**COMMANDER 114 SERIES
SERVICE PUBLICATIONS**

The following is a numerical list of all active Service Bulletins.

SERVICE BULLETIN NO. SB-114-1

AILERON CONTROL CHAIN REROUTING

Figure 1.

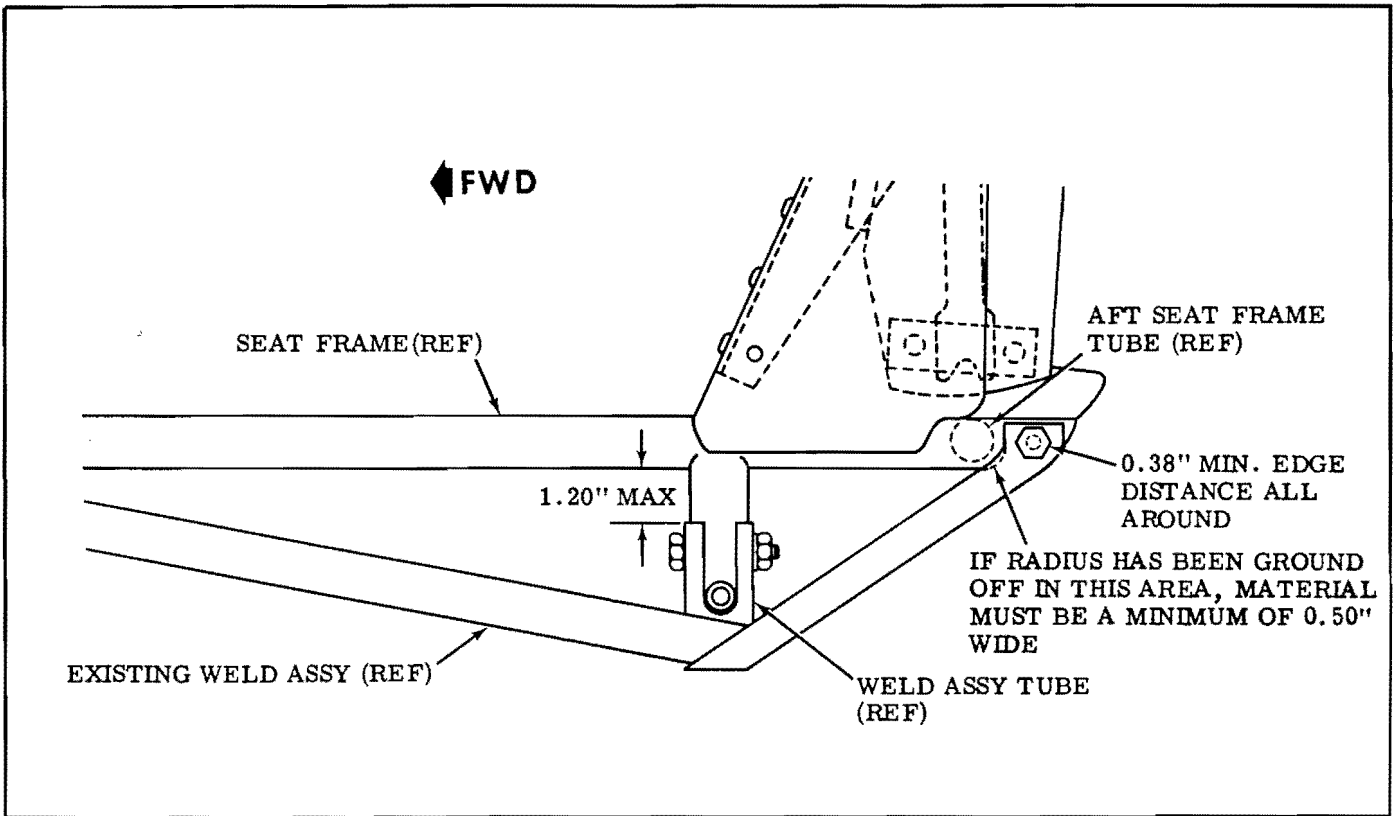
1. Inspect weld assemblies, installed on outboard side of pilot seat and front passenger seat, for correct installation dimensions as shown in Figure 1.
2. If dimension between weld assembly tube and seat frame exceeds 1.20-inches, proceed to Part II (see Figure 1.).

3. If radius of aft inboard strap of weld assembly has been ground off to clear aft seat frame tube and strap is less than 0.50-inch wide in that area, proceed to Part II (see Figure 1.).
4. If edge distance (ED) on bolt mounting holes of either aft inboard or aft outboard strap is less than 0.38-inch, proceed to Part II (see Figure 1.).
5. If all dimensions of installed weld assemblies are as shown in Figure 1., fill out and mail Compliance Card and note on Compliance Card that all dimensions are acceptable.
6. Proceed to RECORD COMPLIANCE.

Figure 2.

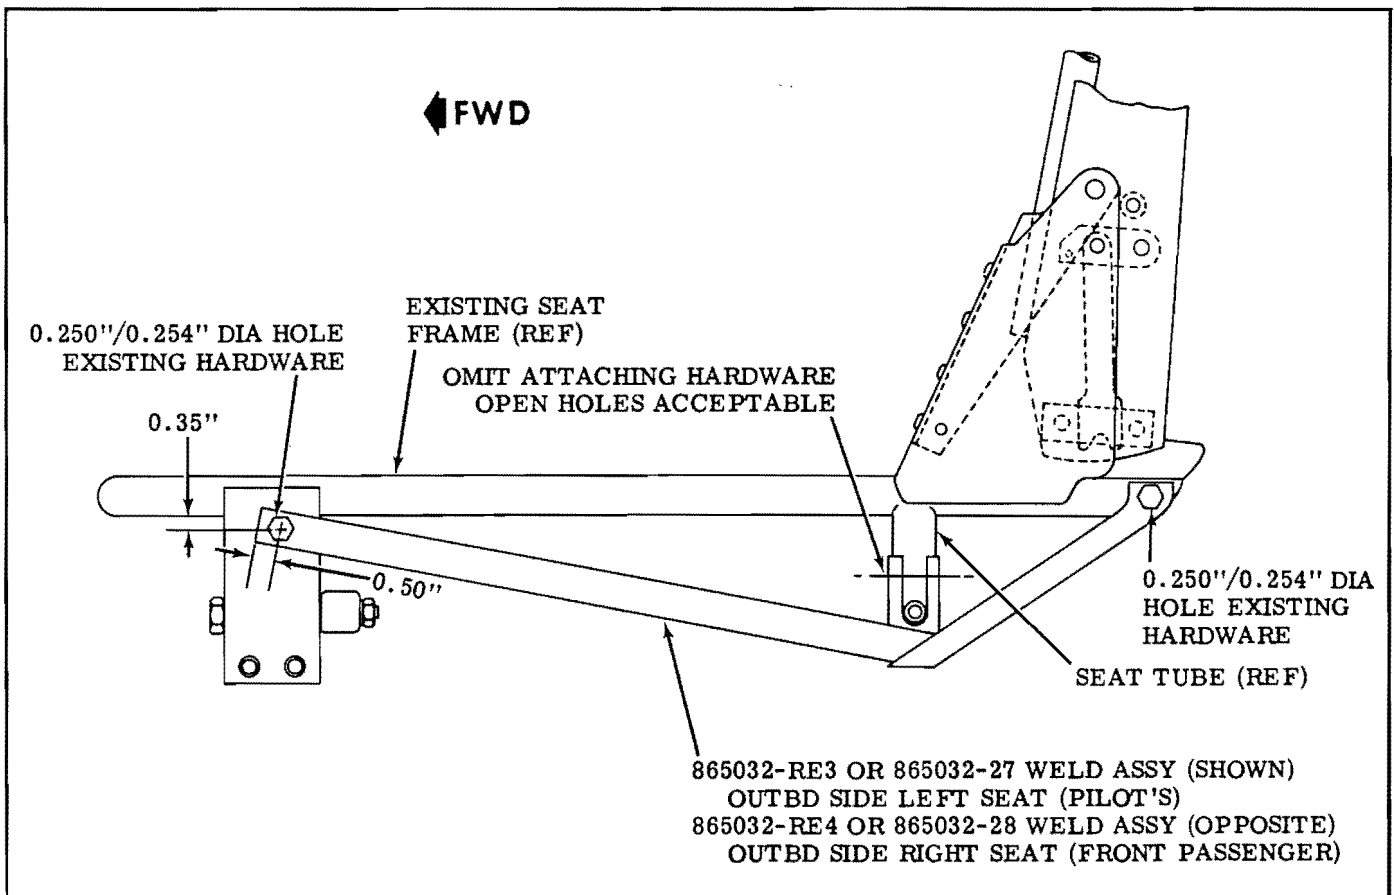
1. Remove pilot seat and/or front passenger seat, to be reworked, from airplane.
2. Remove and discard existing weld assembly from seat.
3. Locate, back drill through existing holes and install 865032-RE3 or 865032-27 left weld assembly on pilot seat bottom and 865032-RE4 or 865032-28 right weld assembly on front passenger seat bottom (see Figure 2.).

Figure 1.

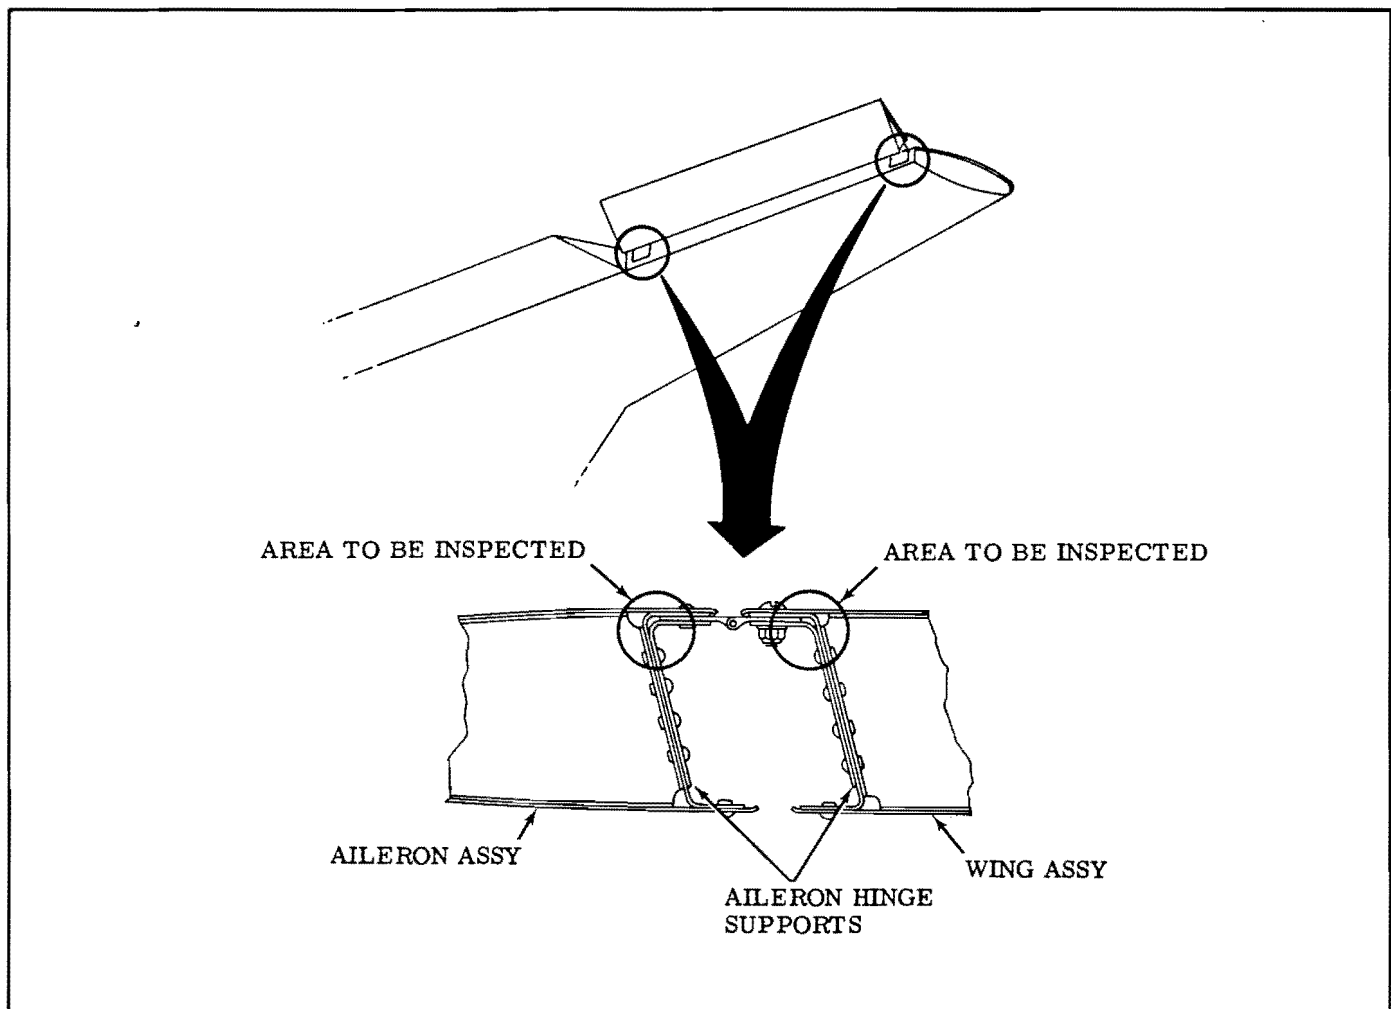
1. Before next flight, inspect the airplane structure at all aileron hinge positions. If visual inspection does not reveal distortion of aileron skin or readily visible cracks in hinge supports, the airplane may undertake a ferry flight to a Base where the complete inspection can be accomplished.

4. Dye penetrant inspect all aileron hinge supports for possible cracks in areas of bend radius (see Figure 1.).
5. If cracks are found in any aileron hinge support, proceed to Step 2. of Part II.

Figure 2.

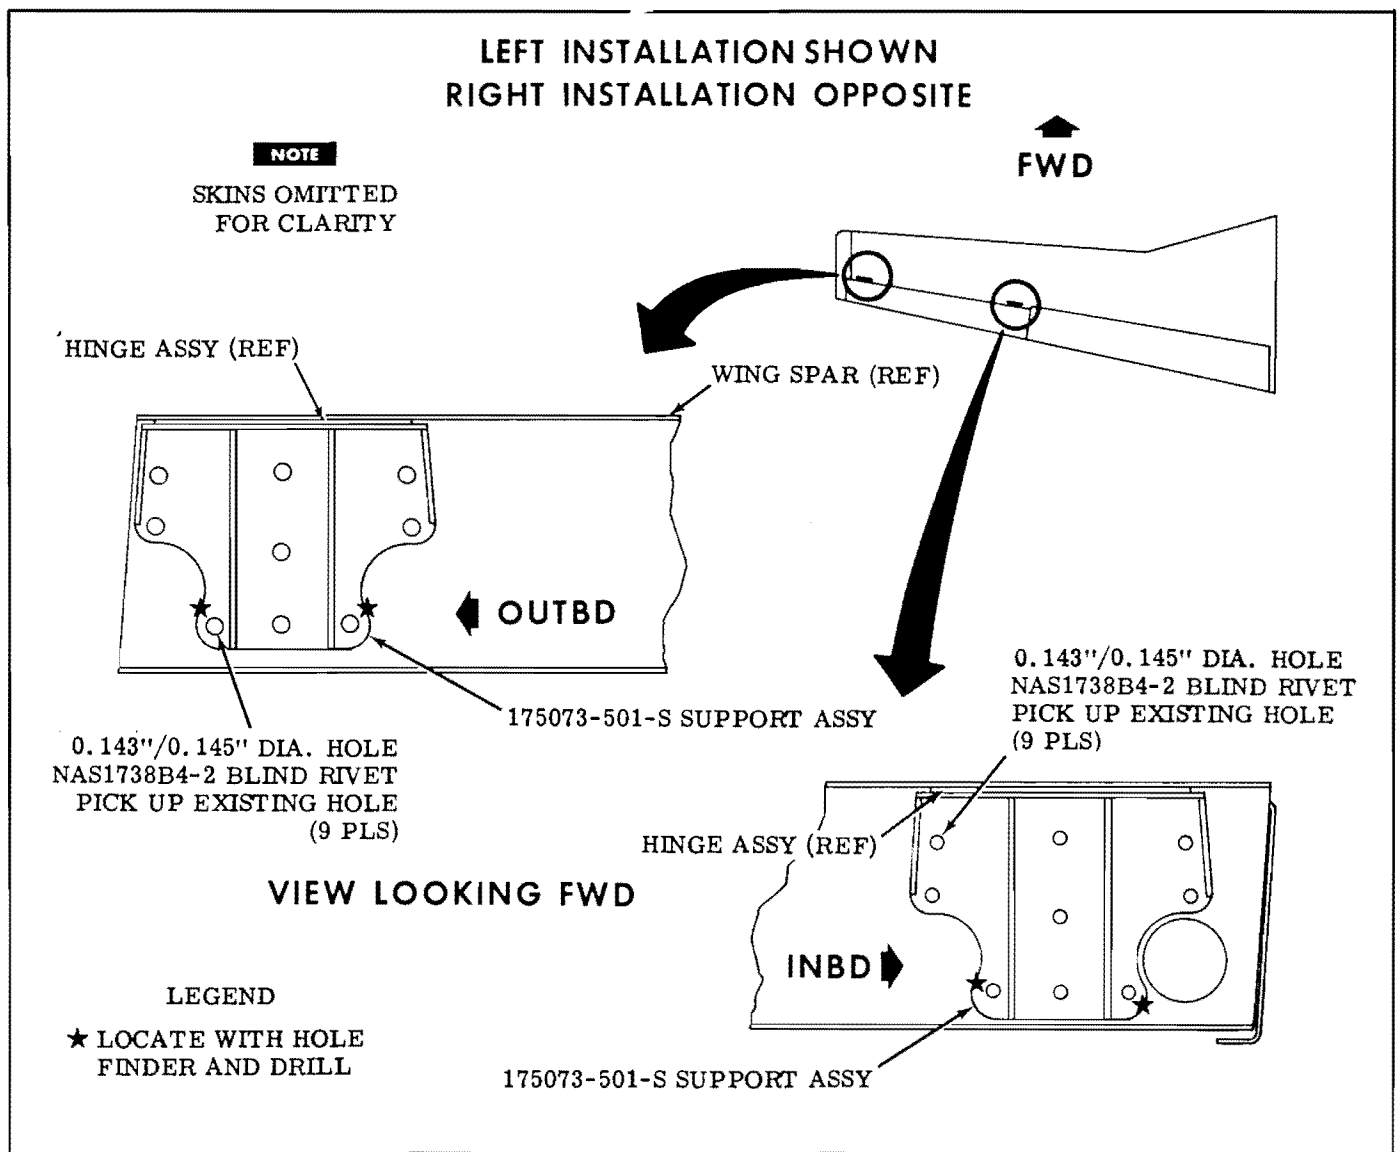
8. Locate, drill and install 175073-501-S support assemblies on left and right wing spars as follows:
 - a. Position and clamp existing hinge assembly and 175073-501-S support assembly on wing spar and drill upper flange of support assembly picking up existing holes in upper wing skin and spar flange (see Figure 2.).

- b. Using a hole finder, locate the existing lower outboard hole and lower inboard hole in the wing spar and drill through support assembly (see Figure 2.).

- f. Drill remaining holes (7 places) in new hinge support assembly (see Figure 2.).
 - g. Install 175073-501-S support assemblies on left and right wing spars picking up existing holes in spars (see Figure 2.).

Figure 4. (Sheet 1 of 3)

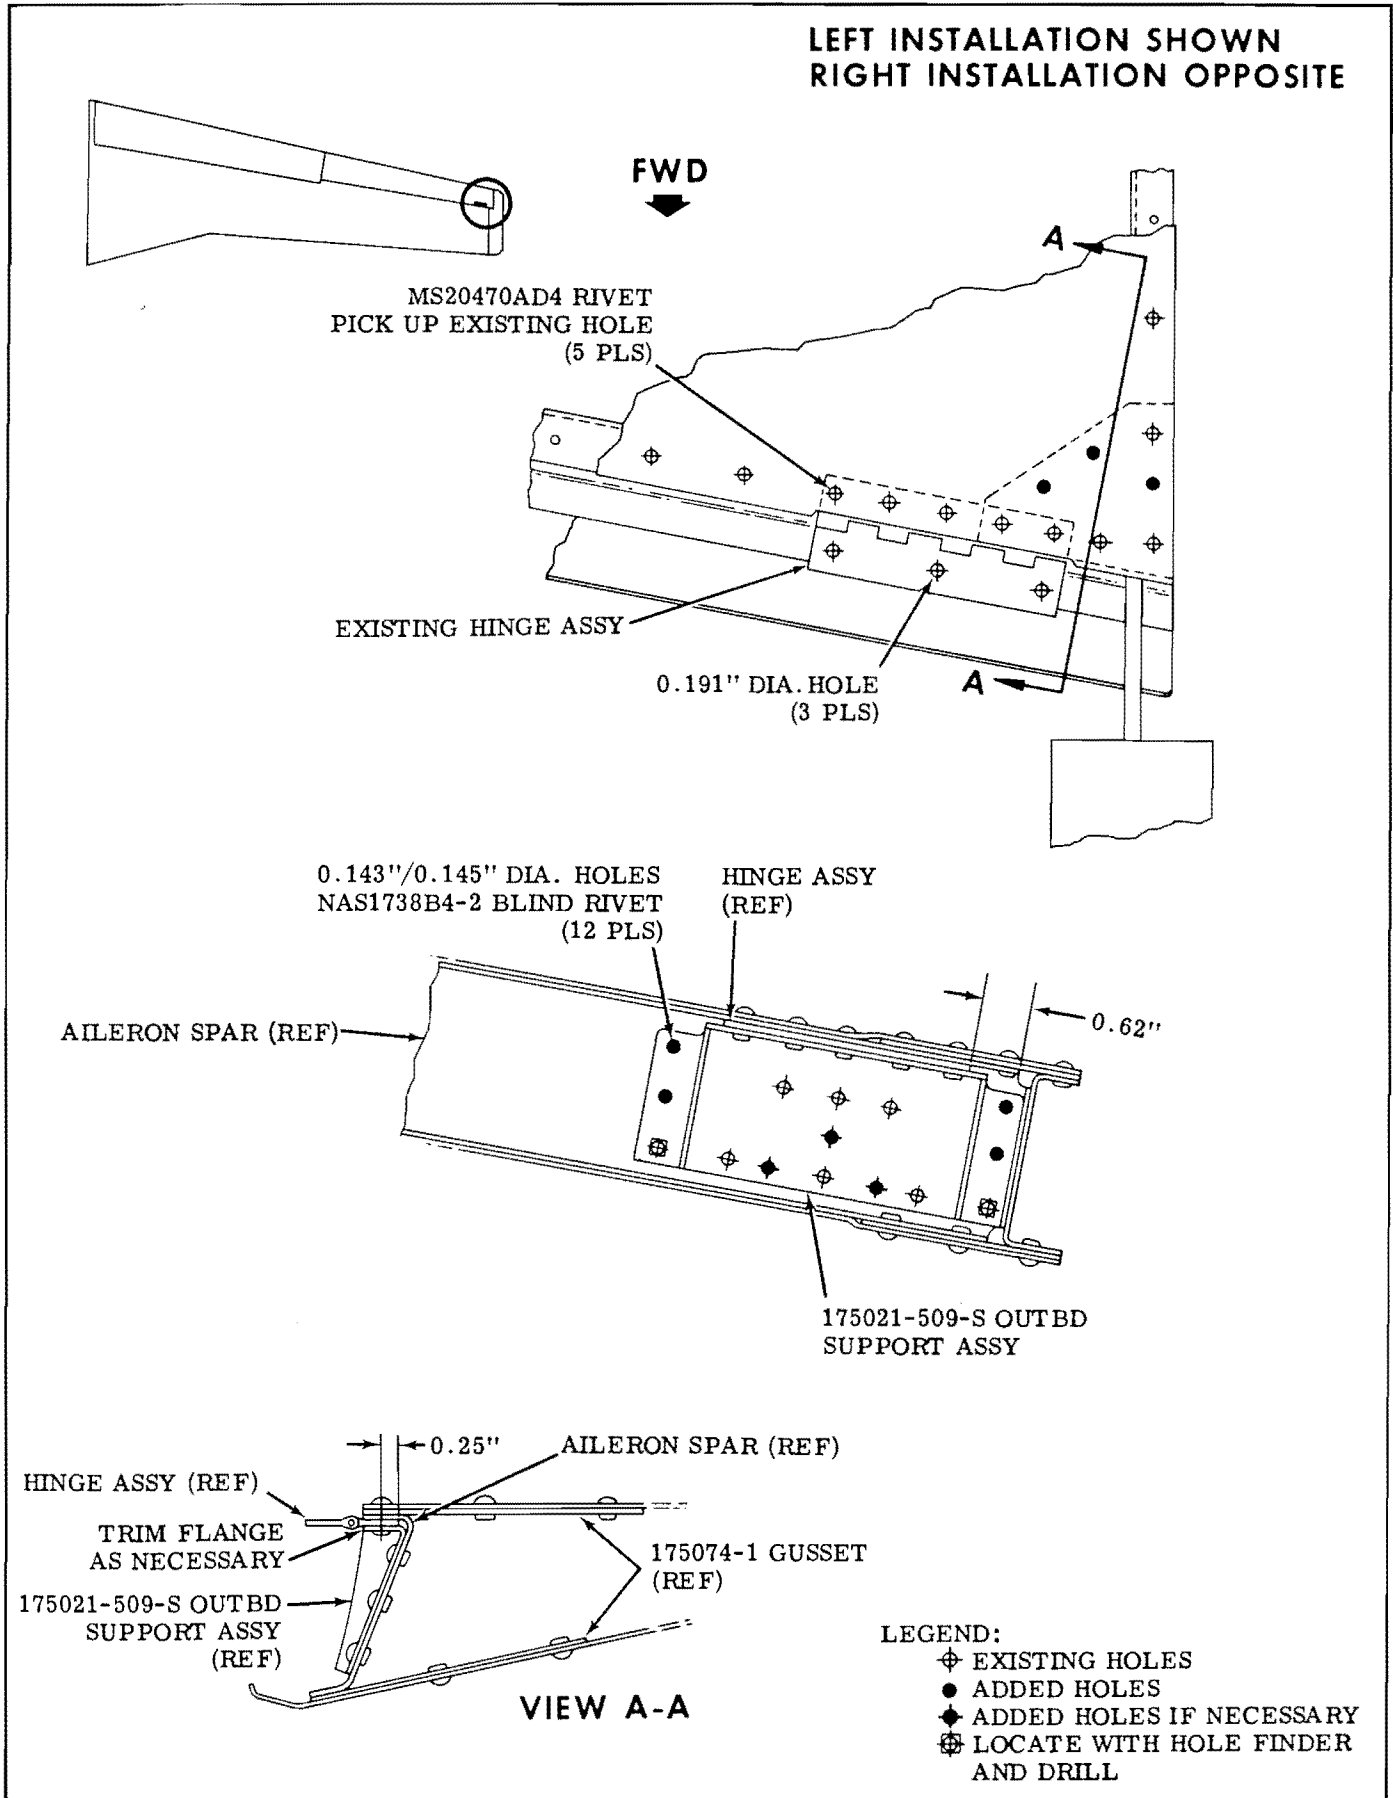
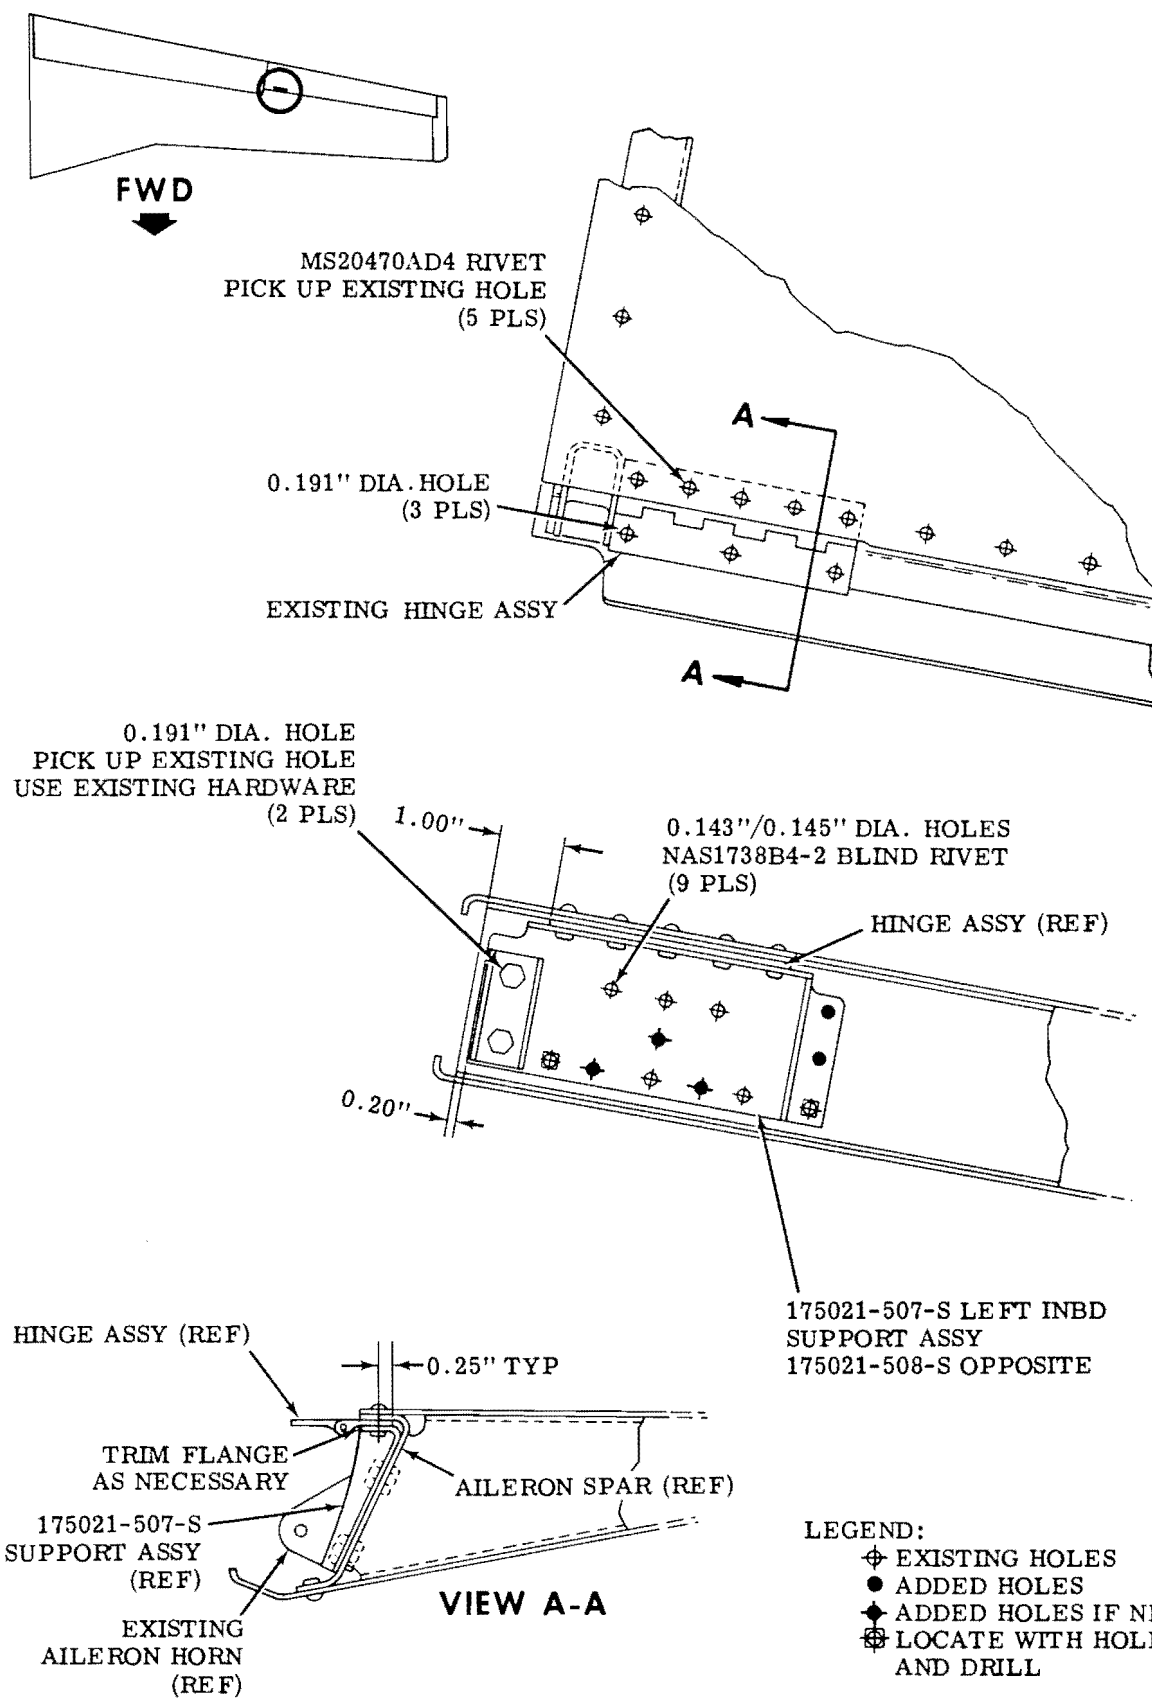
- a. Locate and drill upper flange of support assembly picking up existing holes in aileron and aileron hinge assembly (see Figure 4.).

- h. Drill the three (3) upper middle holes and the lower middle hole only in the new hinge support assembly (see Figure 4. , Sheet 3 of 3) ( and ).
- i. If the two (2) pilot holes in support assembly (drilled at factory) align with holes in template, drill holes to 0.144 (\pm 0.001) inch diameter (see Figure 4. , Sheet 3 of 3).
- j. If the two (2) pilot holes in support assembly (drilled at factory) do not align with holes in template, relocate and drill two (2) lower holes in support assembly 0.50-inch from pilot holes drilled by factory (see Figure 4. , Sheet 3 of 3).

- k. Locate and drill two (2) new upper outboard holes and two (2) new upper inboard holes in hinge support assembly (see Figure 4. , Sheet 3 of 3).

- l. Install 175021-507-S and -508-S inboard support assemblies, 175021-509-S outboard support assemblies, existing hinge assemblies and 175074-1 gussets on aileron (see Figures 3. and 4.).
11. Install ailerons on airplane as outlined in the Airplane Maintenance Manual, Section VII.
12. Fill out and mail Compliance Card.
